Re: Addendum to the Revised Remedial Design/Remedial Action Work Plan  
Amtrak Sunnyside Yard, Queens, New York

PROJECT NAME:  
**REMEDIAL DESIGN/ REMEDIAL ACTION WORK PLAN OU-3**  
PROJECT FOR:  
**AMTRAK SUNNYSIDE YARD QUEENS, NEW YORK**

TITLE:  
**DUAL PHASE VACUUM EXTRACTION SYSTEM EQUIPMENT AND PIPING LAYOUT (REVISED)**

TITLE:  
**PROCESS AND  
INSTRUMENTATION DIAGRAM**

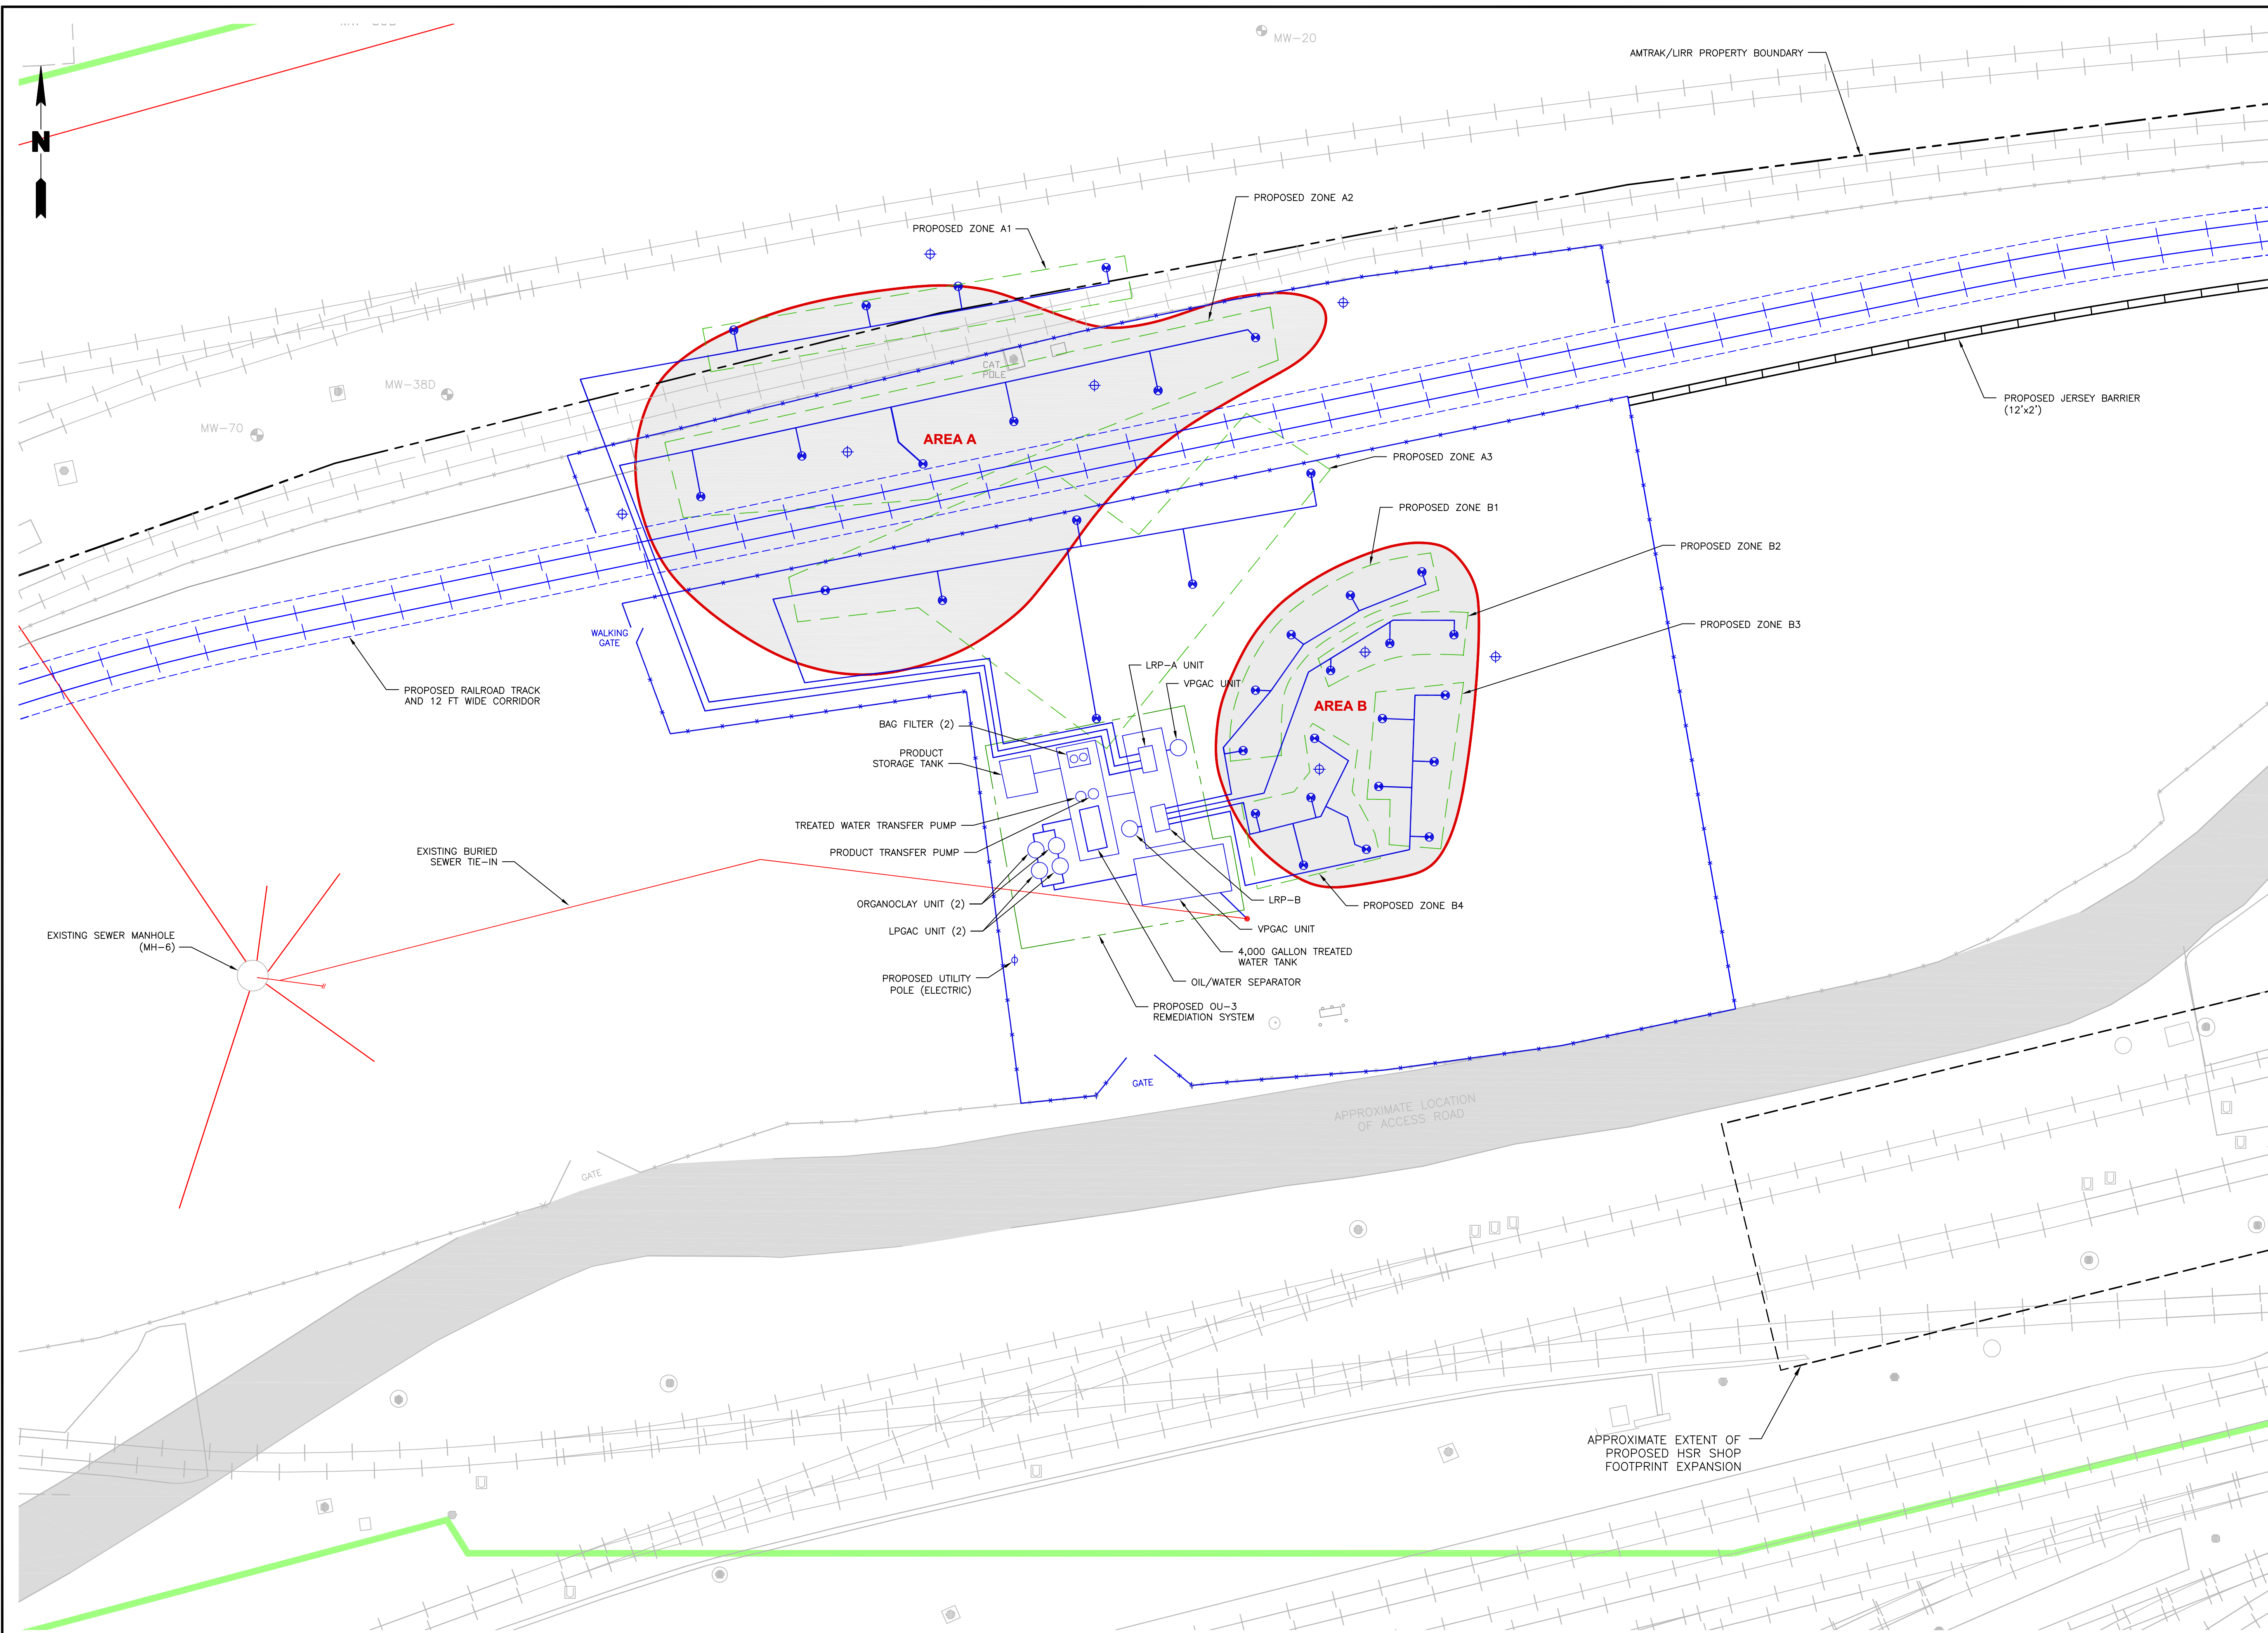
- Reconfigure the location of the remediation system equipment to allow for Amtrak's proposed extension of the High Speed Train Facility building and relocated roadway, as shown on Drawing 1.

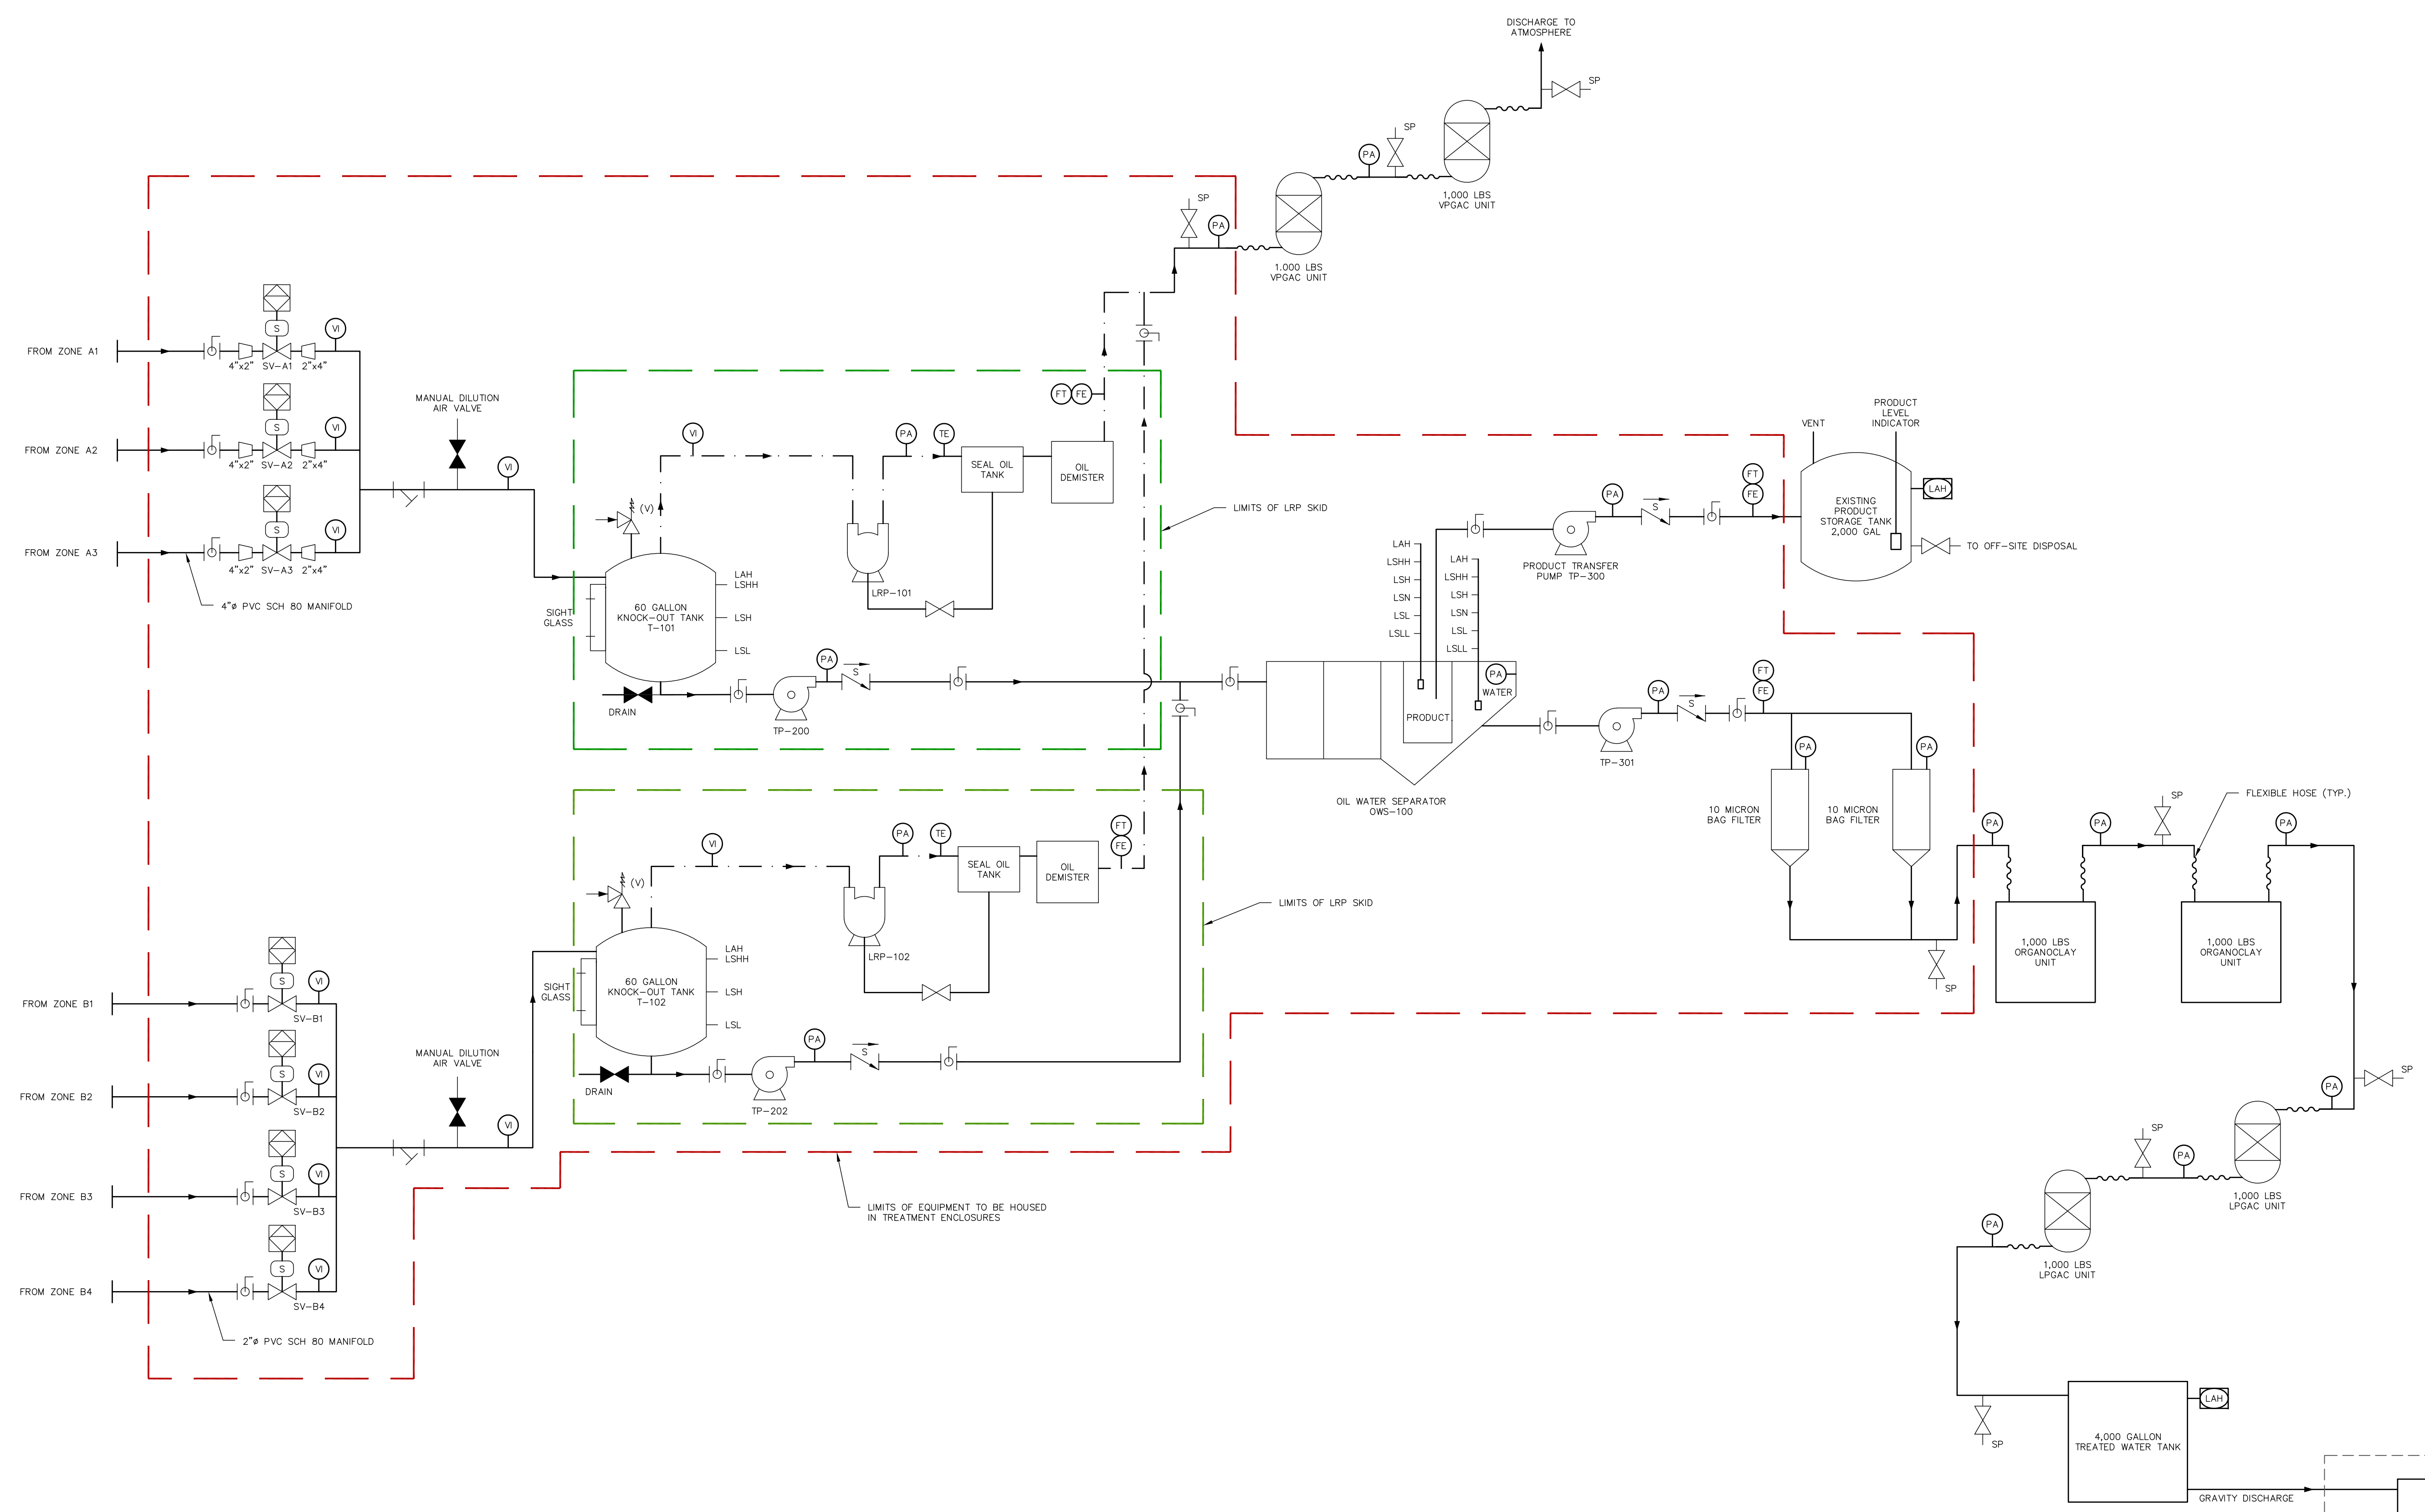
- Operate the system using two liquid ring pumps (LRPs) rather than four. Each LRP will be the same size and will apply a vacuum up to 10 to 12 DPVE wells and/or two zones. The LRPs have been increased in size to be capable of handling approximately 600 cubic feet per minute (cfm) and 29 inches of mercury (in. of Hg). Each LRP will be interconnected to each zone to allow for maximum operational flexibility during LRP maintenance.

- Each zone (up to 6 DPVE wells) will have dedicated two-way, normally closed solenoid valves to allow for automation of each zones operation. The previous design assumed all zones would have been turned on or off manually. This will allow for more efficient operation of each zone for any defined period of time of hours or days.

- Increase the size of the oil water separator (OWS) from 45 gpm to 200 gpm. During the pilot study emulsified product/water was seen in the water effluent chamber in the 10 gpm OWS used for the pilot study. Emulsification of product can reduce the performance level of the OWS. By providing additional capacity in the OWS, it will allow the emulsified product/water mixture pumped from the knockout tanks of the LRPs to separate prior to effluent discharge. This will

An updated process and instrumentation diagram reflecting the changes described above is provided as an attachment (Drawing 2).
